ADDENDUM NO. 03

LOPER ELEMENTARY SCHOOL RENOVATION

ADDENDUM NO. THREE

PROJECT: Shelbyville Central Schools – 2022 Loper Elementary Renovation

HD101A

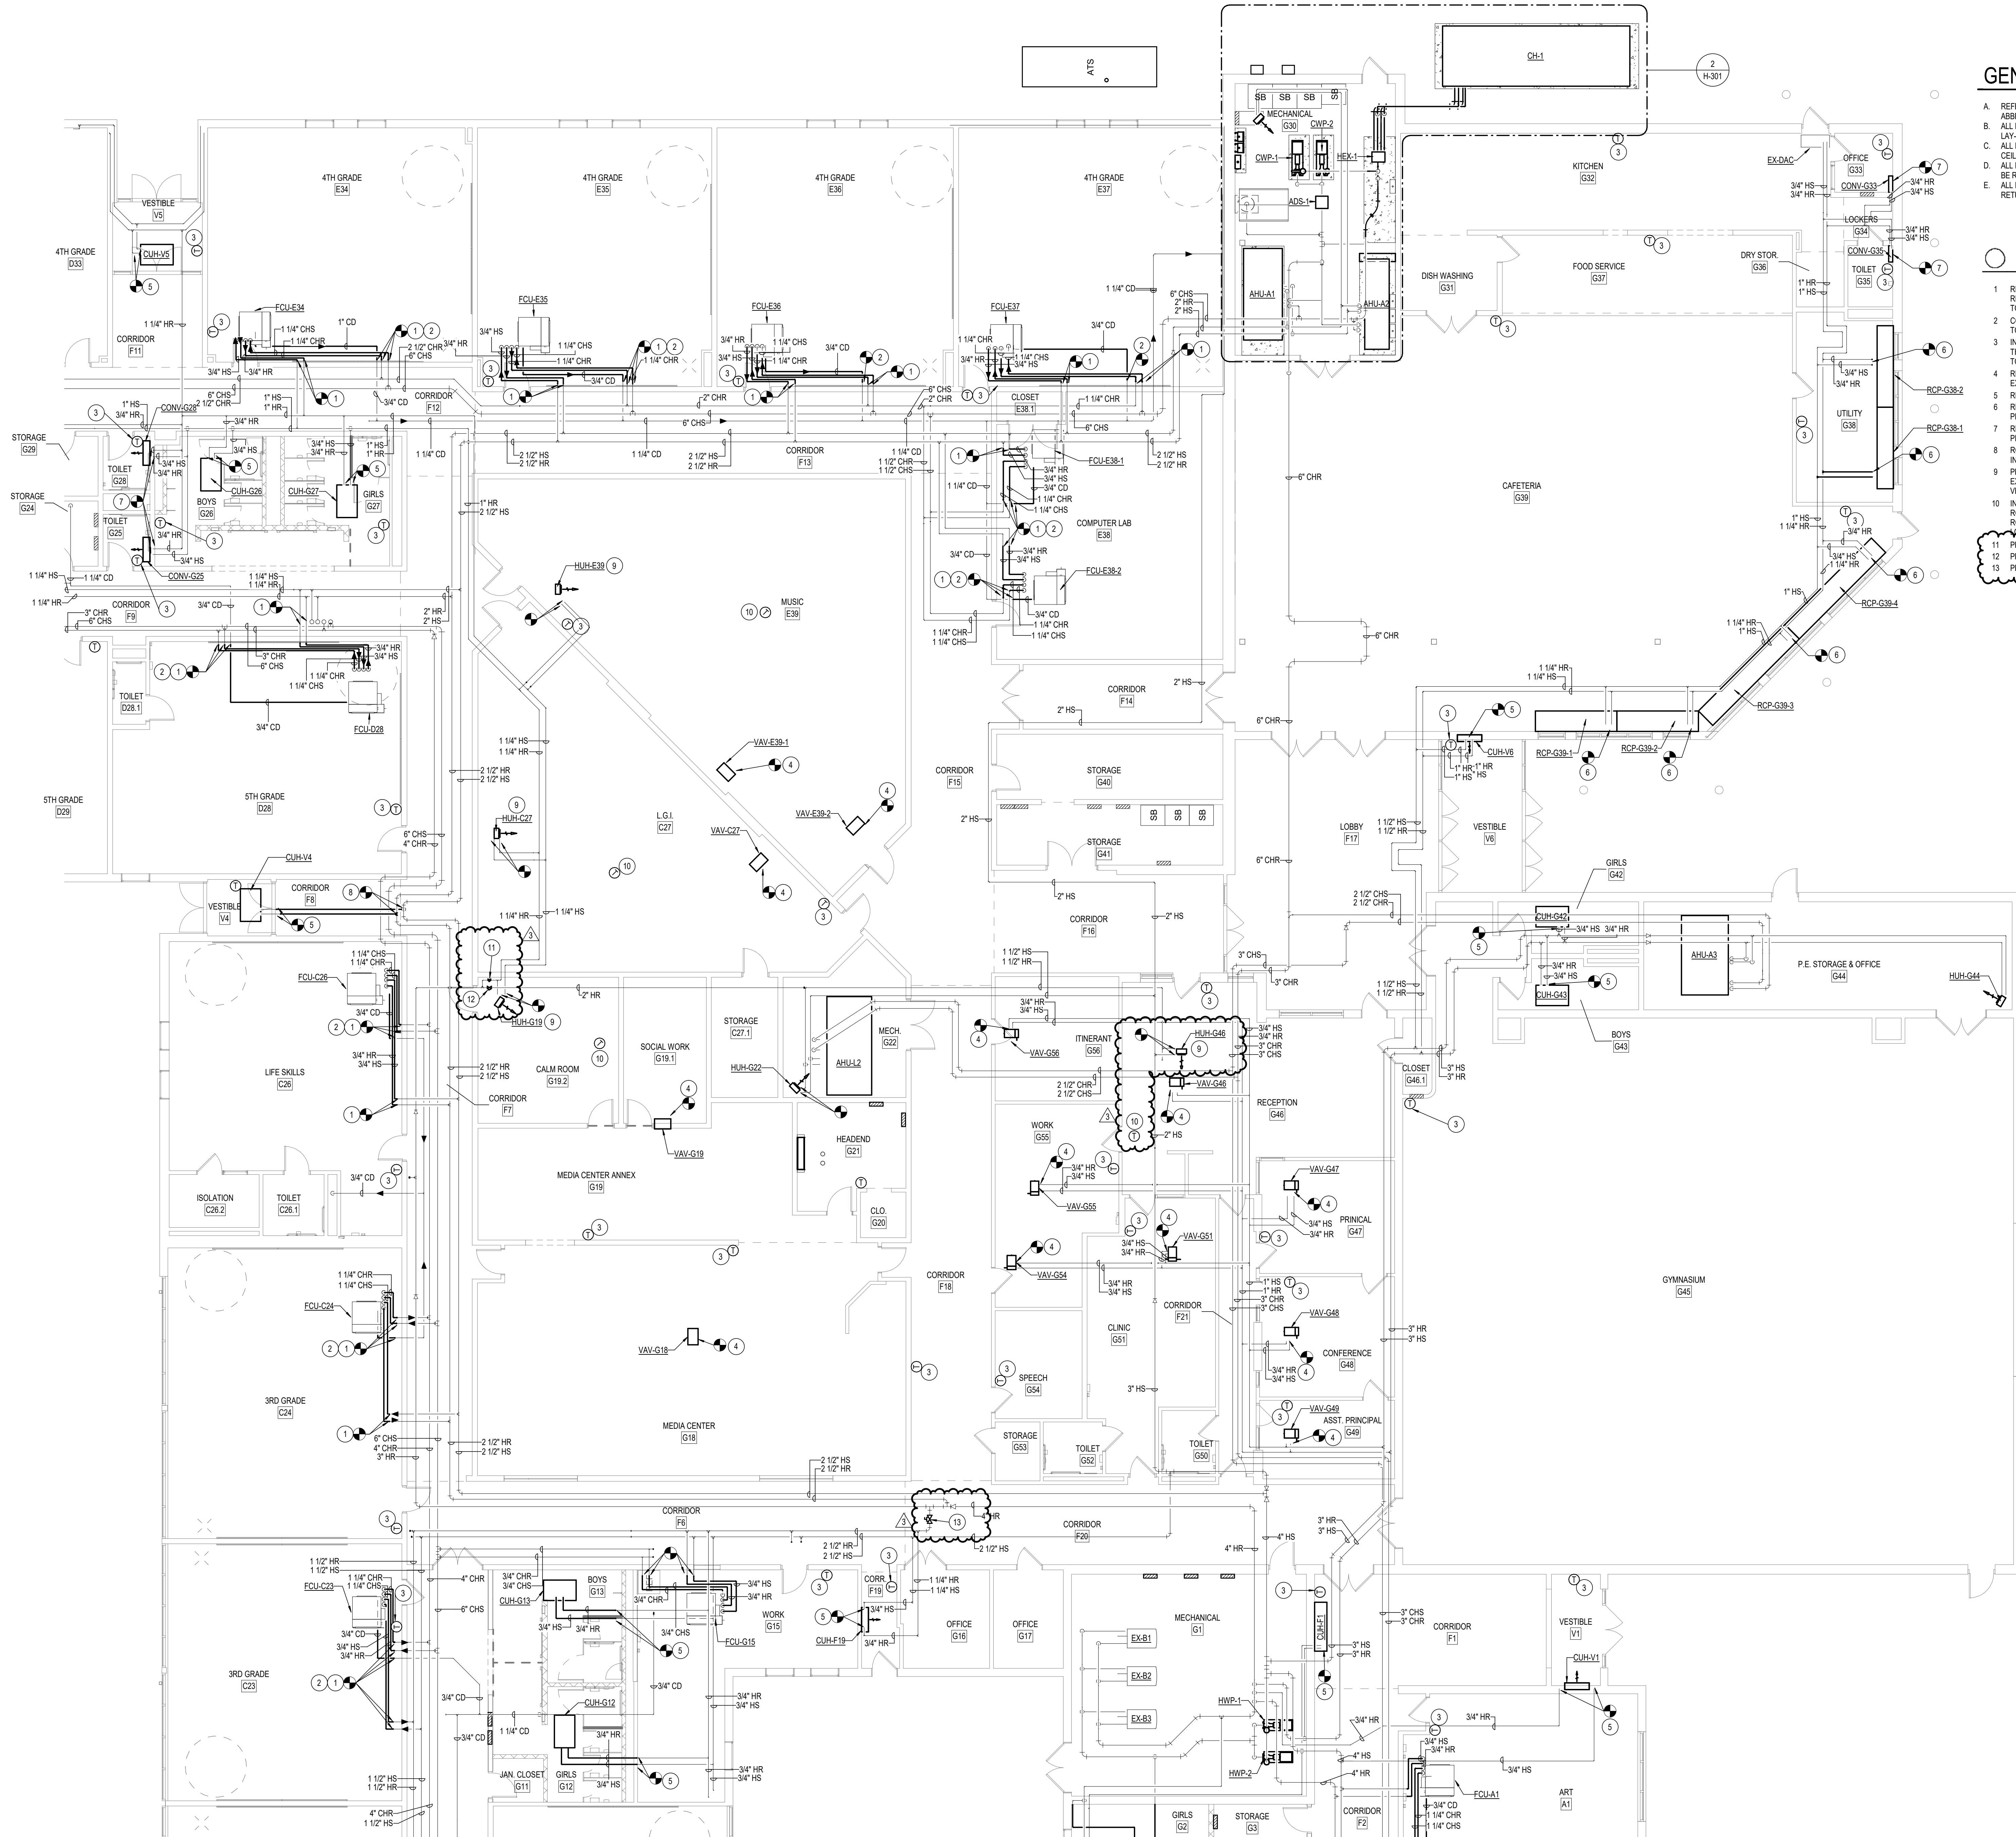
- A. Demo existing Circuit Setters.
- B. Revise Sheet Plan Note #13.

- 13 DISCONNECT AND REMOVE EXISTING CIRCUIT SETTER. PREPARE AND PROTECT FRESH OPENINGS FOR NEW WALL STAT AND CONTROL WIRING. READY CURBS FOR NEW FAN AND PROVIDE A4-CURBS AS REQUIRED. COORDINATE WITH DIV. 26

1 FIRST FLOOR HVAC PIPING PLAN - UNIT A
1/8" = 1'-0"

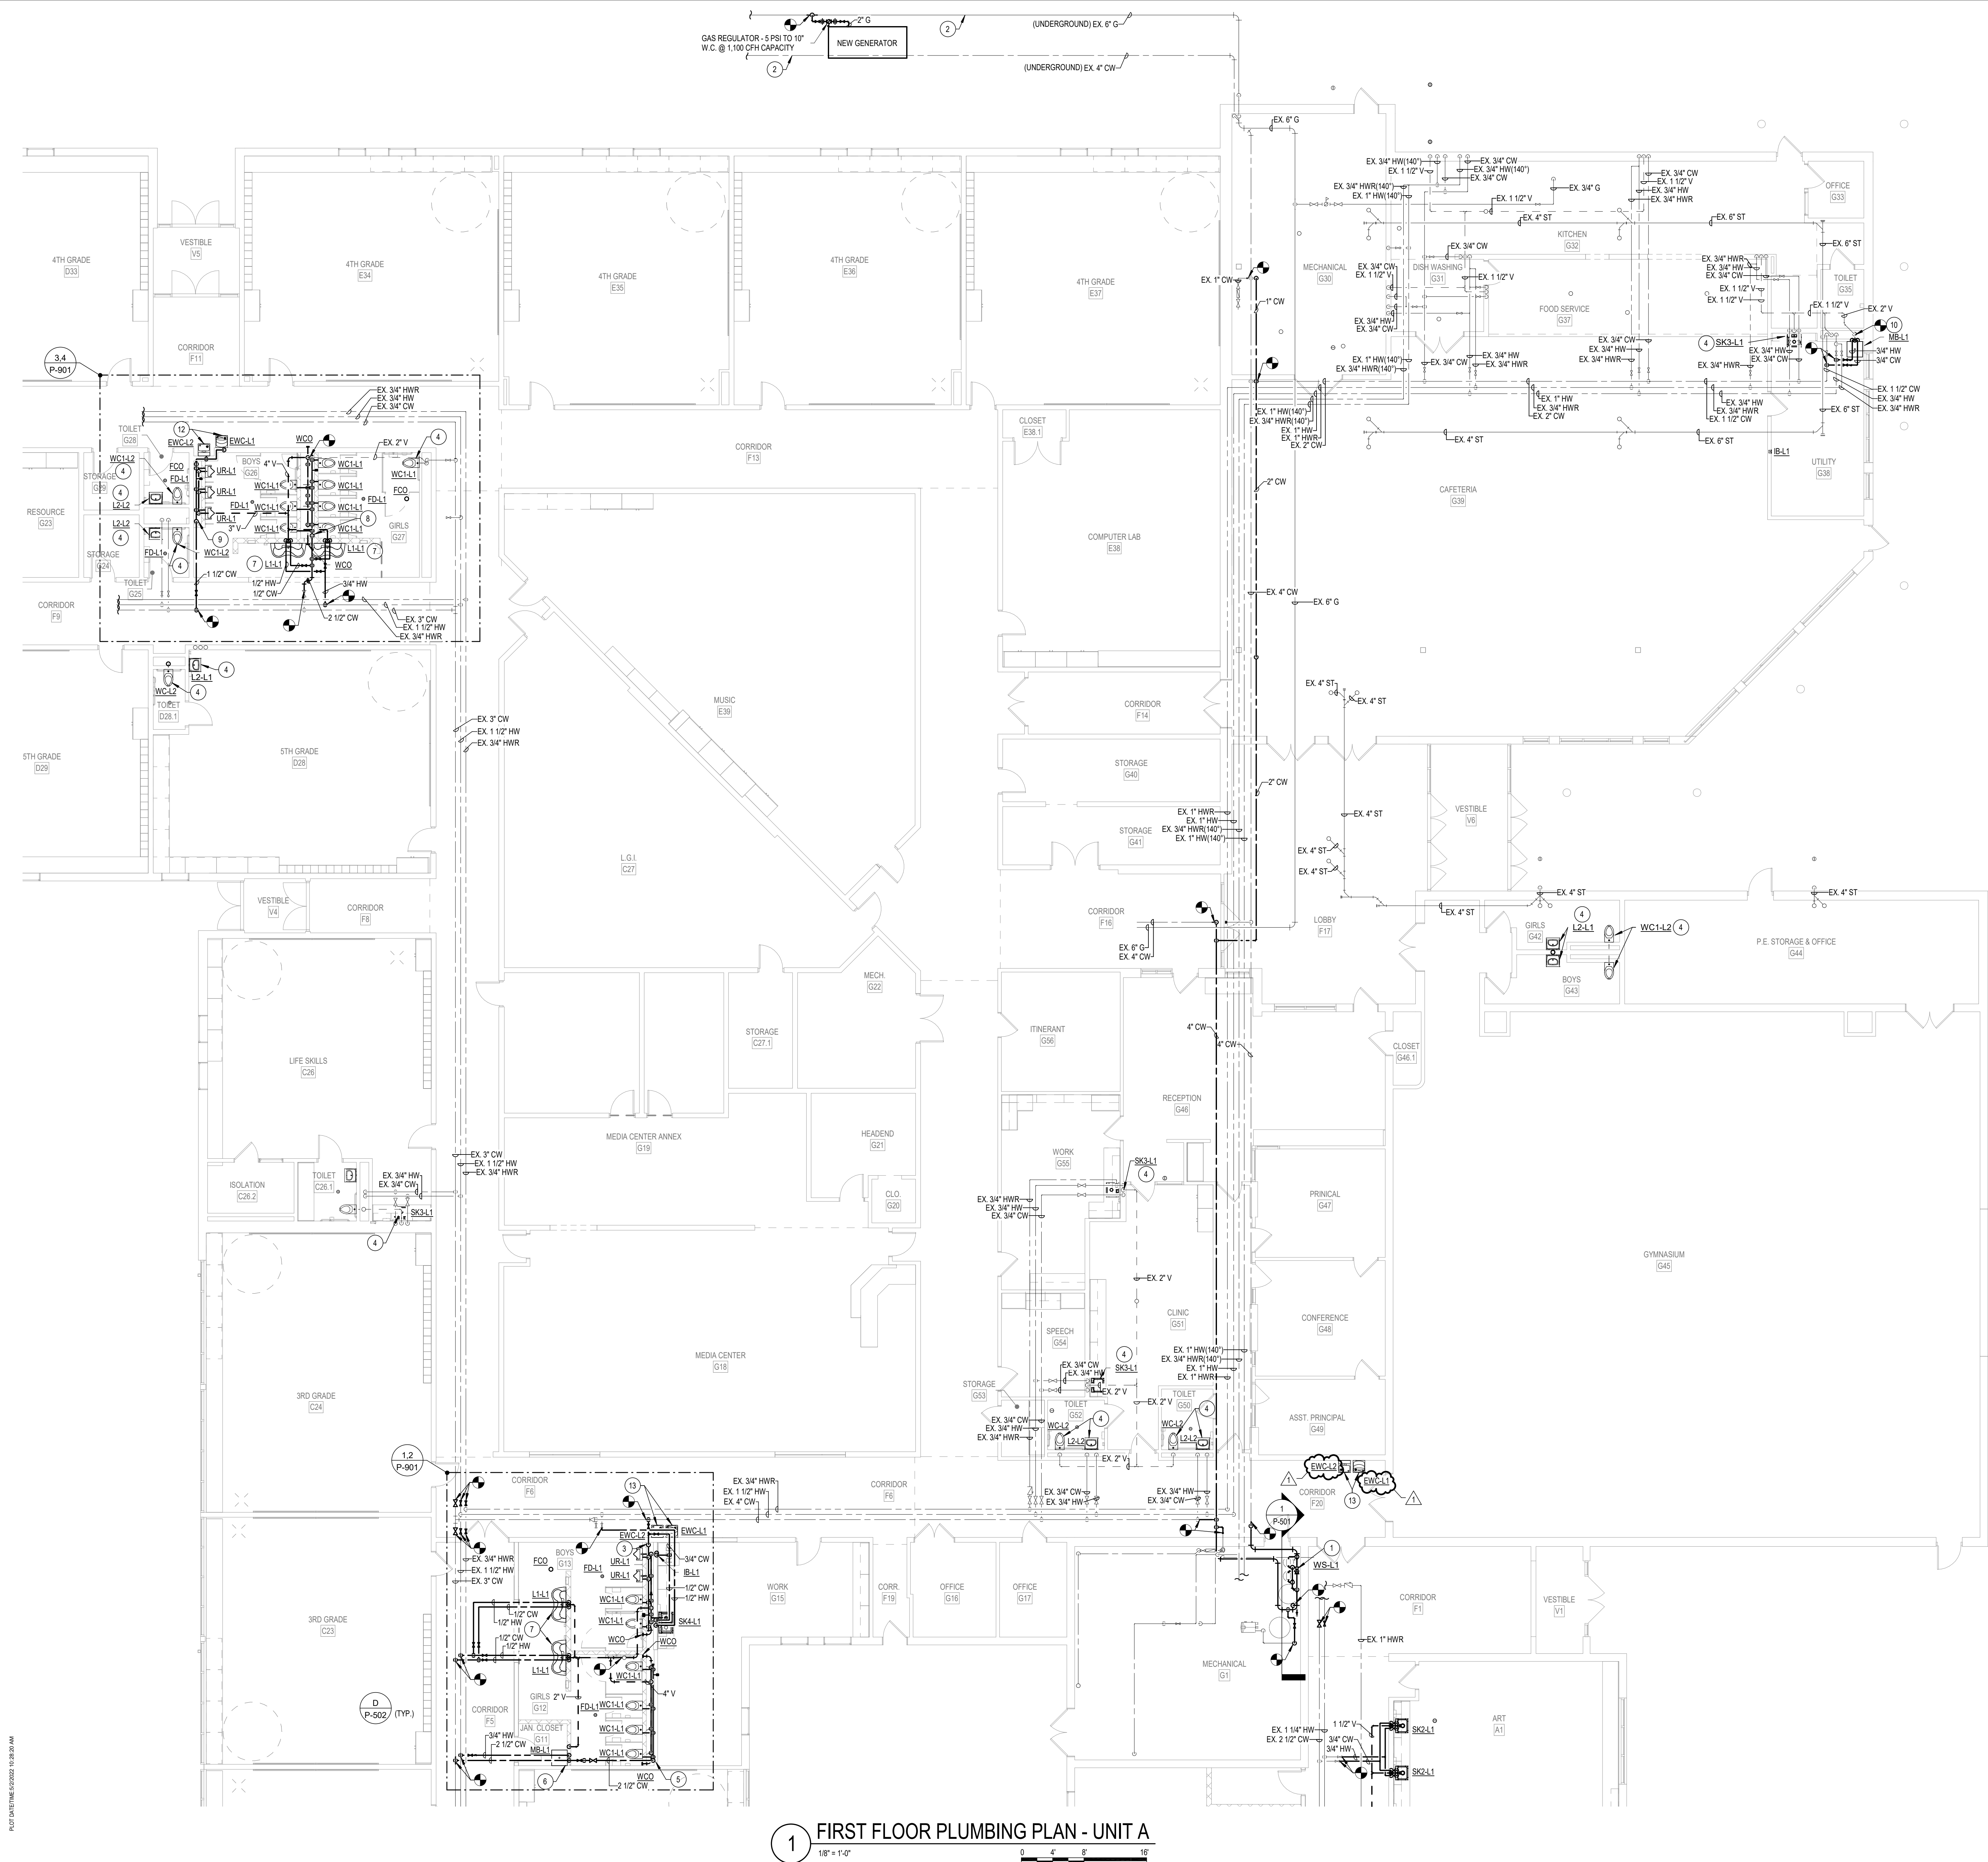
- A. Add HUH-G46 and associated thermostat.
- B. Add new Circuit Setters.
- C. Add Plan Note #11.
- D. Add Plan Note #12.
- E. Add Plan Note #13.

- 11 PROVIDE NEW CIRCUIT SETTER SET TO 31.6 GPM.
- 12 PROVIDE NEW CIRCUIT SETTER SET TO 19.1 GPM.
- 13 PROVIDE NEW CIRCUIT SETTER SET TO 63.9 GPM.

FIRST FLOOR
ELECTRICAL
DEMO PLAN -
UNIT C

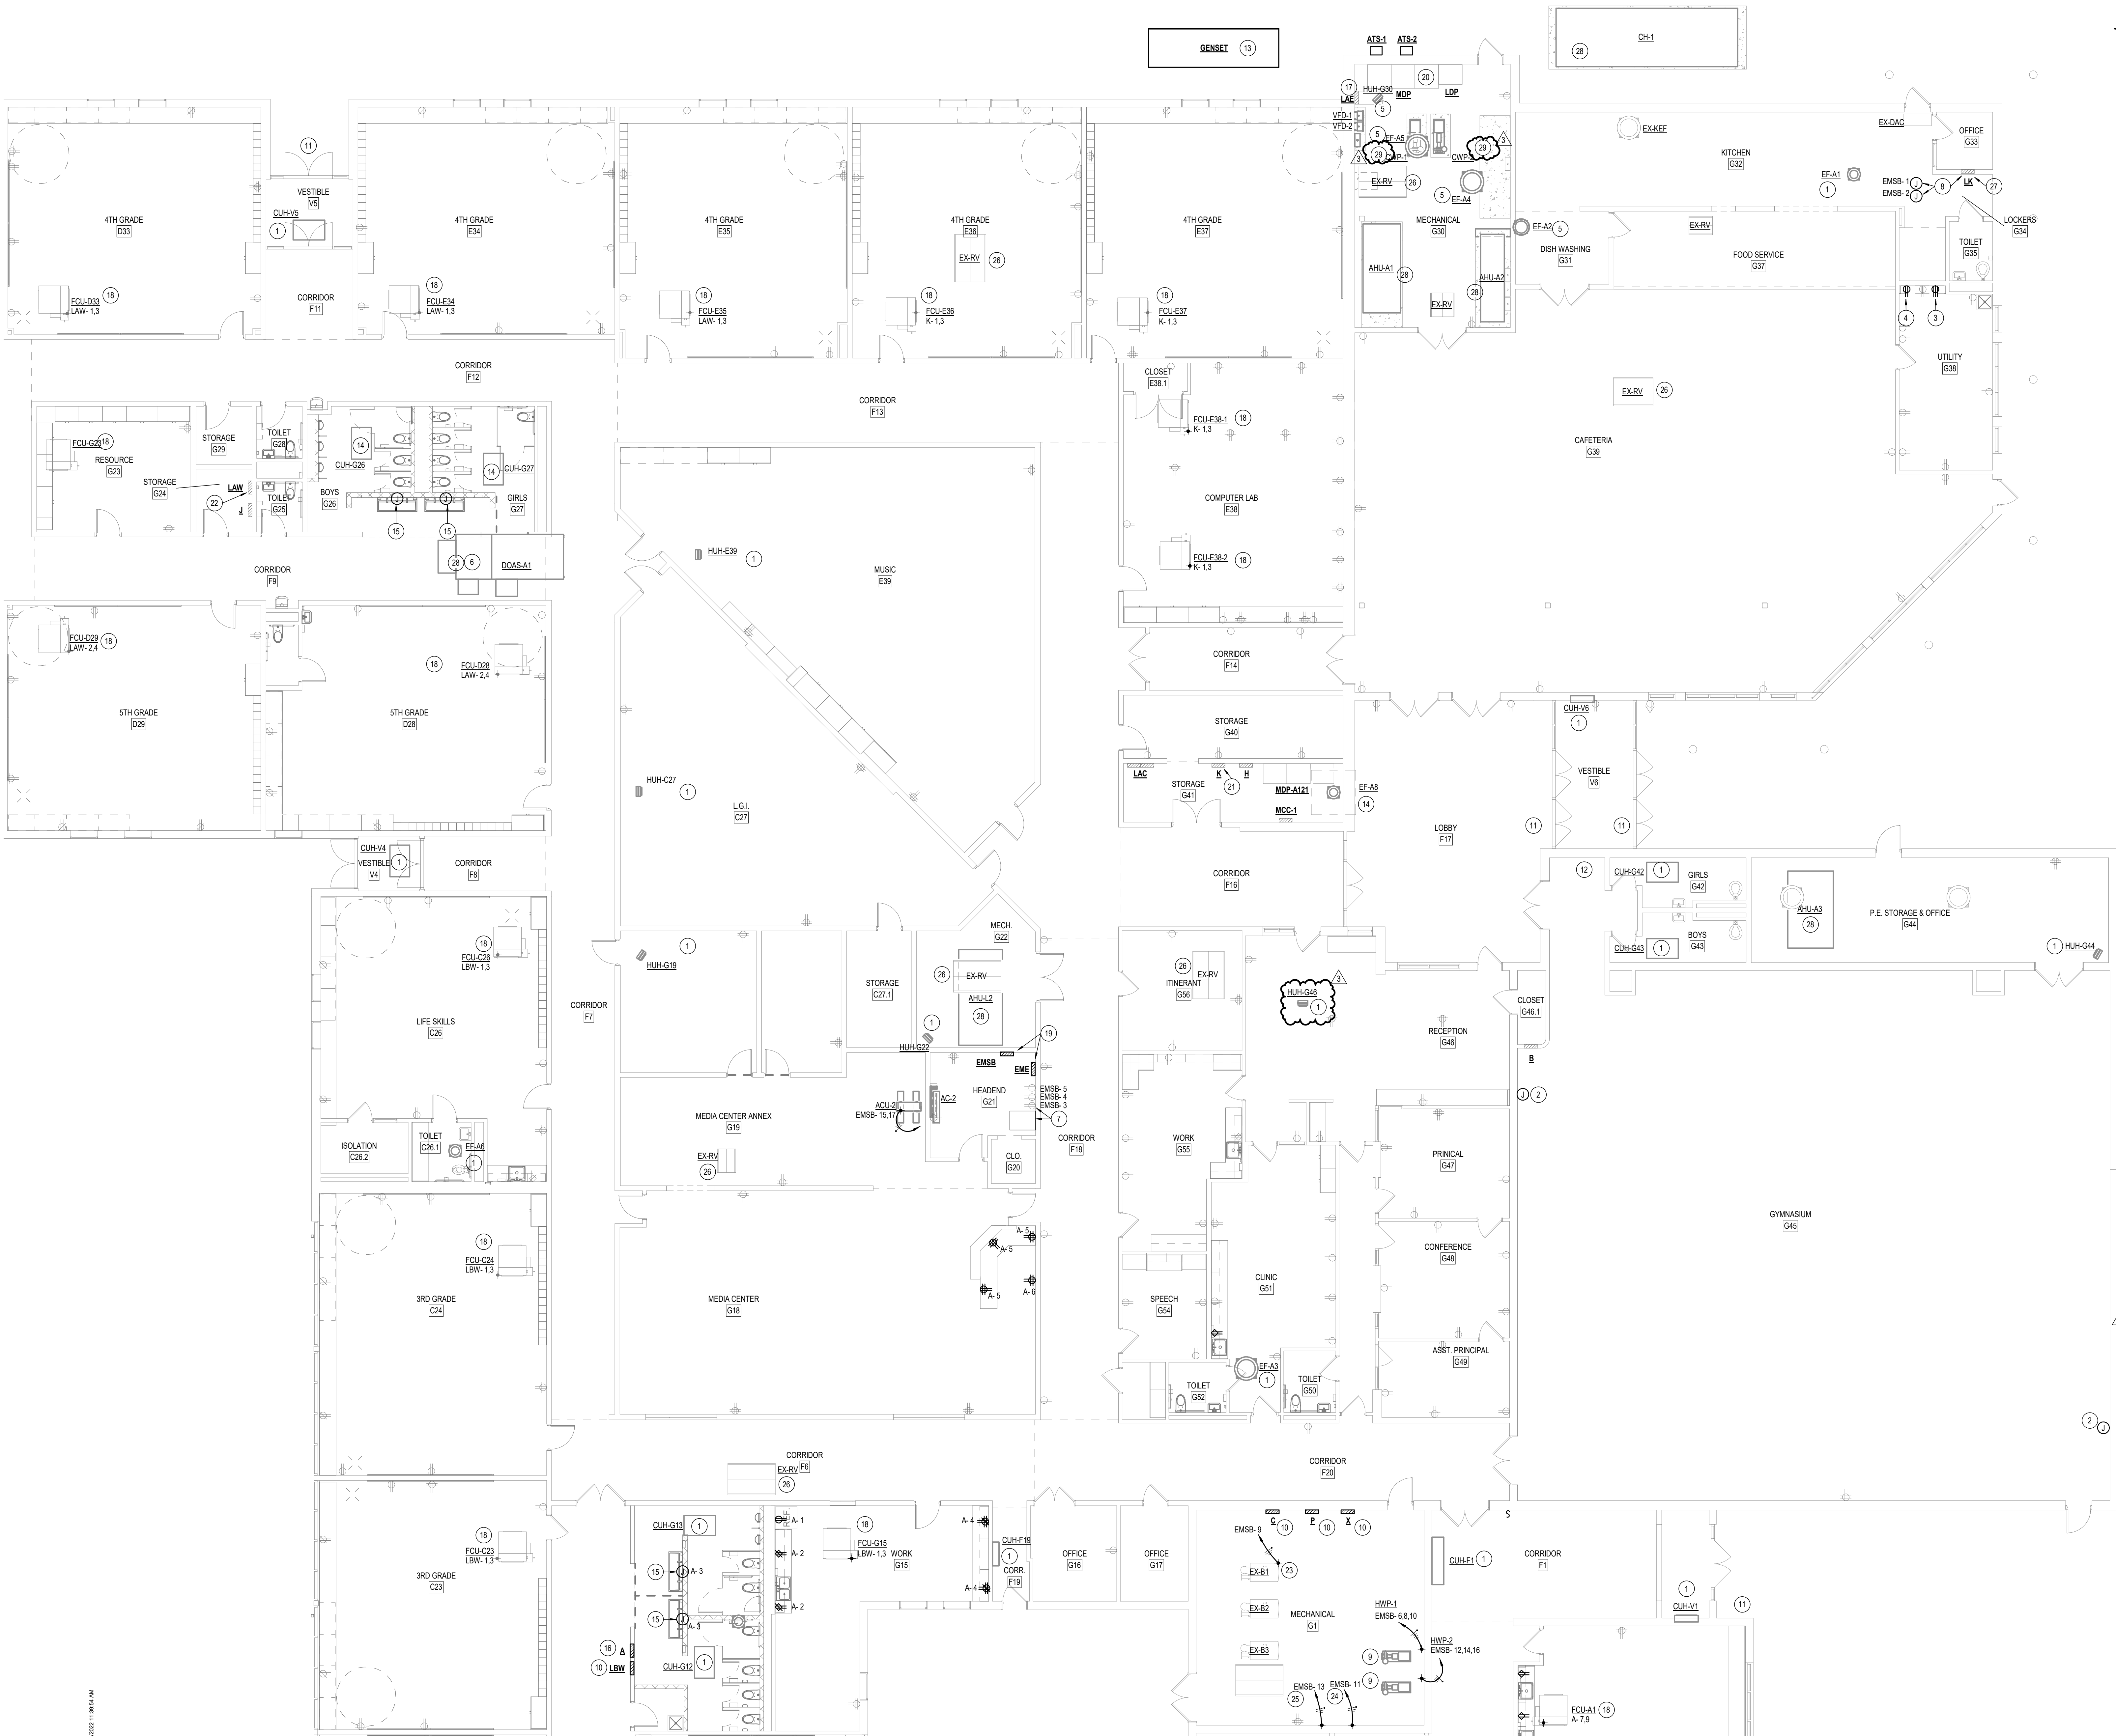
- A. Motorized equipment schedule updated for CWP sizes
- 3.07 EP101A- First Floor Power Plan – Unit A
 - A. Plan note 1 added for mechanical equipment HUH-G46
 - B. Plan note 29 added for CWP circuitry
- 3.08 ED101A – First Floor Demo Plan – Unit A
 - A. Shading updated for existing to remain data outlets.
 - B. Plan note 14 added for CWP circuitry
- 3.09 ET101A – First Floor Technology Plan – Unit A
 - A. Added existing WAP locations.
 - B. Updated plan note G to call out number of data cables from data outlets.
 - C. Added note calling out MDF room.
 - D. Added data for scoreboards.
- 3.010 ET101B – First Floor Technology Plan – Unit B
 - A. Added existing WAP locations.
 - B. Updated plan note G to call out number of data cables from data outlets.
 - C. Added note calling out IDF room.
- 3.011 ET101C – First Floor Technology Plan – Unit C
 - A. Added existing WAP locations
